Project	IEEE 802.16 Broadband Wireless Access Working Group < http://ieee802.org/16 >
Title	Efficient Signaling to Support Partitioning/Grouping for H-FDD Operation
Date Submitted	January 14, 2008
Source(s)	E-mail: Pallav Sudarshan Pallav.Sudarshan@motorola.com Jeff Zhuang Jeff.Zhuang@motorola.com Mark Cudak Mark.Cudak@motorola.com Motorola, Inc. < http://standards.ieee.org/faqs/affiliationFAQ.html >
Re:	IEEE 802.16 Working Group Letter Ballot Recirc #26a
Abstract	Clarifications and signaling mechanisms are provided for efficient operation of H-FDD in 802.16e.
Purpose	Accept the proposed specification changes on IEEE P802.16Rev2/D2.
Notice	<i>This document does not represent the agreed views of the IEEE 802.16 Working Group or any of its subgroups. It represents only the views of the participants listed in the "Source(s)" field above. It is offered as a basis for discussion. It is not binding on the contributor(s), who reserve(s) the right to add, amend or withdraw material contained herein.</i>

Efficient Signaling to Support Partitioning/Grouping for H-FDD Operation

Figure 59—Example of burst FDD bandwidth allocation

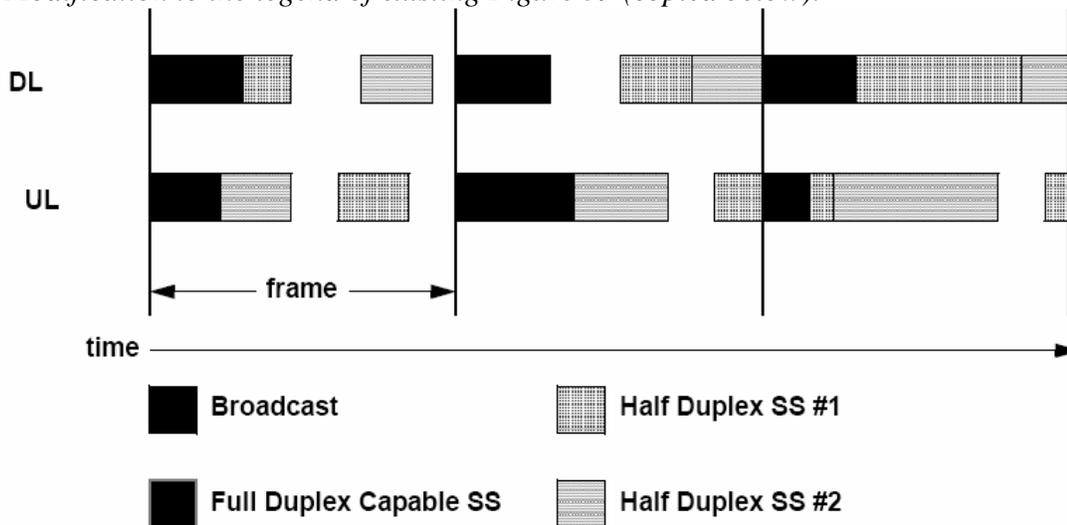
I. Modification to the legend of existing Figure 59 (copied below):

Fig 59 should denote the different temporal regions more generically as “**Half Duplex Partition #1**” and “**Half Duplex Partition #2**”, instead of “Half Duplex SS #1” and “Half Duplex SS #2”.
